Service Bulletin

FLUID LEAKAGE FROM BRAKE RESERVOIR CAP

2001-2002 Tributes

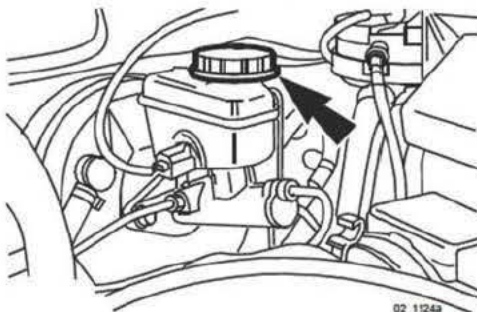
Some vehicles may exhibit fluid leakage from the brake reservoir cap. This may be caused by the insufficient sealing of the cap.

To improve the sealing, a new brake reservoir cap is available to prevent this condition.

1. Verify concern.
2. Remove the brake reservoir cap by turning counterclockwise.
3. Install a new cap and turn it clockwise to secure.

NOTE: Turn the cap until it completely stops.

4. Replace Caution Label with a new one. (You can attach the new label over the old one.)

- Be aware of the direction of the label: the text part faces toward the front of the vehicle.
- To prevent the label from peeling off, wipe the leaked fluid or dust completely off the tank.
- You can use brake cleaner to degrease if necessary.
